APPLICATION NO.	FILING DATE	FIRST NAMED INVENTOR	ATTORNEY DOCKET NO.	CONFIRMATION NO.	
10/807,349	03/24/2004	Tatsuyoshi Maruyama	023484-0162	5377	
22428	7590 03/09/2006		EXAMINER		
FOLEY AND LARDNER LLP SUITE 500			WUJCIAK,	WUJCIAK, ALFRED J	
3000 K STREET NW			ART UNIT	PAPER NUMBER	
WASHINGTON, DC 20007			3632

This is the first Office Action for the serial number 10/807,349, STRUCTURE FOR FIXING STEERING-GEAR HOUSING, filed on 3/24/04.

See drawing of Figure 3 from Kamoshita et al.'s invention for clarification:

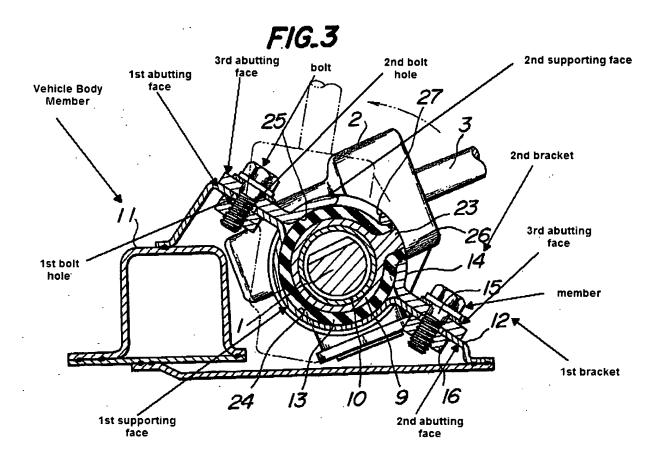
Kamoshita et al. teaches a structure (figure 3) comprising a first bracket (12) comprising a first supporting face supporting one circumferential side face of the steering-gear housing (2), a first abutting face arranged at one circumferential end and abutting on the vehicle-body member (11), a first bolt hole (located where the top bolt is secured therethrough in figure 3) arranged through the first abutting face, and a second abutting face arranged axially opposite to the first abutting face through the first bolt hole. The structure includes a second bracket (14) comprising a second supporting face supporting another circumferential side face of the steering-gear housing, a third abutting face arranged at one circumferential end and abutting on the second abutting face, and a second bolt hole arranged through the third abutting face at a position corresponding to the first bolt hole. The structure includes a member (15) for securing another

circumferential end of the first bracket and another circumferential end of the second bracket. The structure includes a bolt (upper bolt of figure 3) arranged from the second bolt hole through the first bolt hole and that is configured to be inserted through a third bolt hole formed in the vehicle-body member to clamp together the first bracket, the second bracket and the vehicle-body member. The structure includes a cylindrical resilient member (13) arranged between the first and second brackets and the steering-gear housing. The resilient member is formed with a protrusion (adjacent to element 23) on an outer periphery and the second supporting face is formed with a concave engaged with the protrusion. The resilient member is formed with an incision (opening area adjacent to element 23).

Kamoshita et al. teaches the third abutting face but fails to teach the second bolt hole being smaller in an axial length than the first bolt hole. It would have been obvious for one of ordinary skill in the art at the time the invention was made to have modified the size of the second bolt hole smaller in the axial length than the first bolt hole to reduce the length of bolt for connecting the two brackets together.

In regards to claim 2, Kamoshita et al. teaches the first bolt hole but fails to teach the first bolt hole has an axial length larger than a radius of the steering-gear housing. It would have been obvious for one of ordinary skill in the art at the time the invention was made to have modified the size of first bolt hole length larger than the radius of the steering-gear housing to provide designer's preference for the length of hole for retaining a long bolt.

In regards to claim 3, Kamoshita et al. teaches the second bolt hole but fails to teach the second bolt hole comprises a slot. It would have been obvious for one of ordinary skill in the art

at the time the invention was made to have added slot in the second bolt hole to provide adjustable support for allowing the bolt to mount therethrough.

In regards to claim 14, Kamoshita et al. teaches the first bolt hole but fails to teach the first bolt hole has an axial length larger than a radius of steering-gear housing. It would have been obvious for one of ordinary skill in the art at the time the invention was made to have modified the length of first bolt hole larger than the radius of steering-gear housing to increase the stress life on the first bracket from a long period of vibration from engine mounted on frame.

In regards to claim 15, Kamoshita et al. teaches the second bolt hole of the second bracket but fails to teach the second bolt hole is a slot. It would have been obvious for one of ordinary skill in the art at the time the invention was made to have modified the second bolt hole to slot to provide convenience for adjusting the second bracket while the bolt is connected to the first and second brackets.
